| 1. MP 16-002 (City War Memorial)
| 2. DS 16-308 (Henderson)
| 3. DS 276 (Holtkamp)

**MINUTES
CITY OF CARMEL-BY-THE-SEA
HISTORIC RESOURCES BOARD
August 22, 2016**

Fig. 7

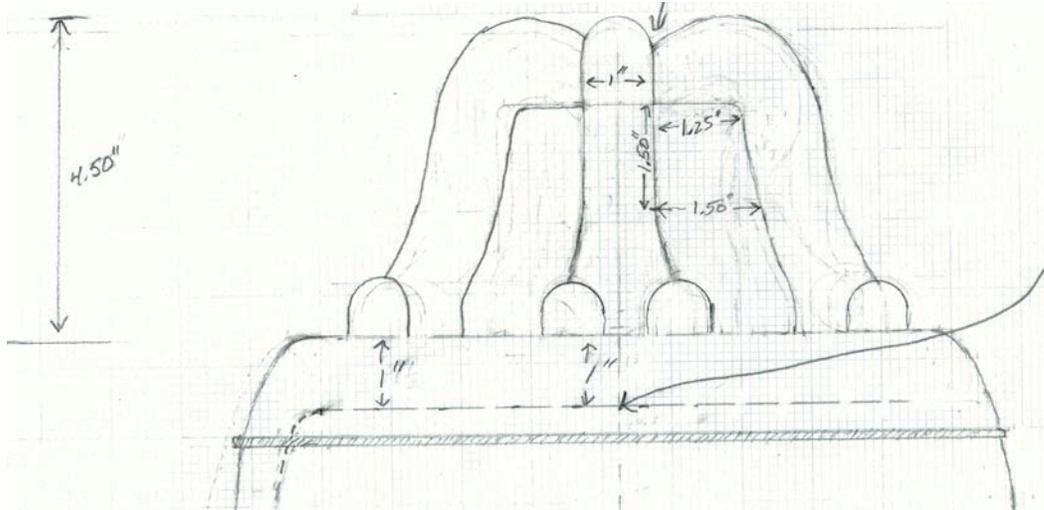
Figure 7 is a shop drawing for the bell crown, which, if you zoom in, will see is designed to take rectangular bronze straps like those in the photos above. Specifically, it is designed to

take two $\frac{3}{4}$ " wide pieces of $\frac{1}{2}$ " sheet bronze as the under brackets, and one piece of 2" wide by $\frac{1}{2}$ " sheet bronze as the bracket over the top of the beam. Four triangular wedges made from the same $\frac{1}{2}$ " material complete the kit.

The beam is 8" tall by 5-11/16" wide. Where the 180° bends are placed and to what extent the straps overlap will determine how long the straight pieces need to be. By my estimate we should start with 30" bars, just to be safe. The 4 wedges may need to be as much as 6" wide and 3" deep, and can be cut from one piece of $\frac{1}{2}$ " plate 6" x 6". We may be able to order these pieces pre-cut from a metal supply house.

Figure 8

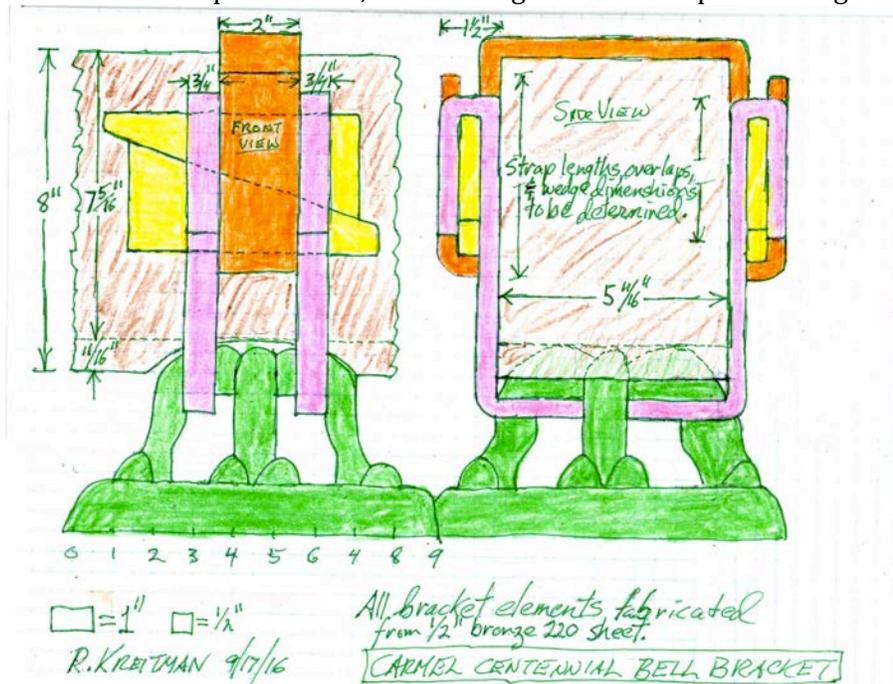
Figure 8 is a colorful and accurate scale rendition of the bracket. One essential element that will have to be worked out by the fabricator is precisely where to place the 180-degree bends, how much overlap there'll be, and how big and what shape the wedges need to be.

STONE VENEER ATTACHMENT DETAIL

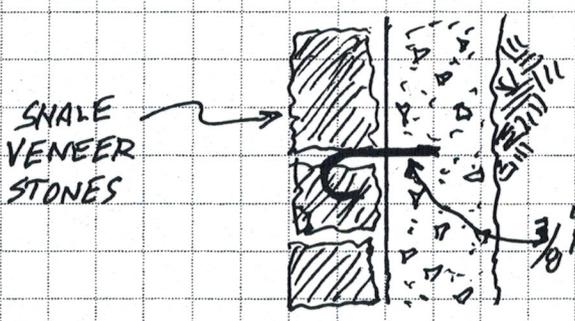
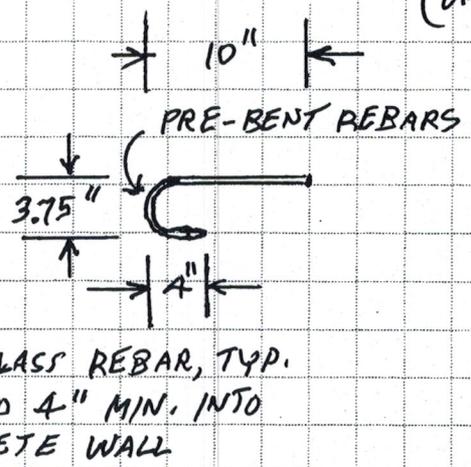
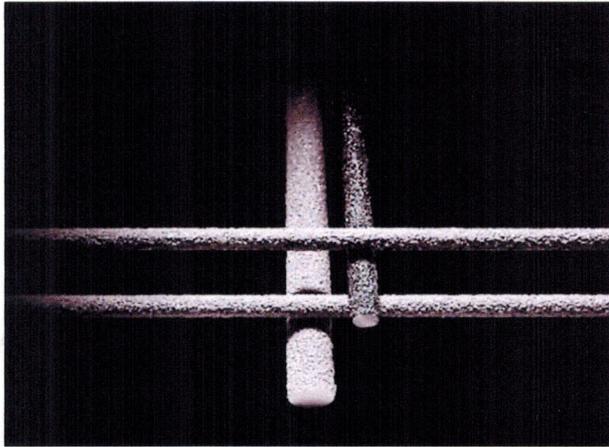
3. The applicant shall make a measure cross-section drawing of the wall structure from the coring holes and note the build-up of the stone, mortar and concrete within the wall to use as a reference for futures repair to the stone work.

5. The stone placement, alignment, and configurations (horizontal and vertical) shall match the existing to the fullest extent possible.
6. Prior to the beginning of construction, the applicant shall convene a pre-construction meeting to include the contractor and the City's Project Planner to ensure compliance with the Secretary of the Interior's Standards for the Treatment of Historic Properties.
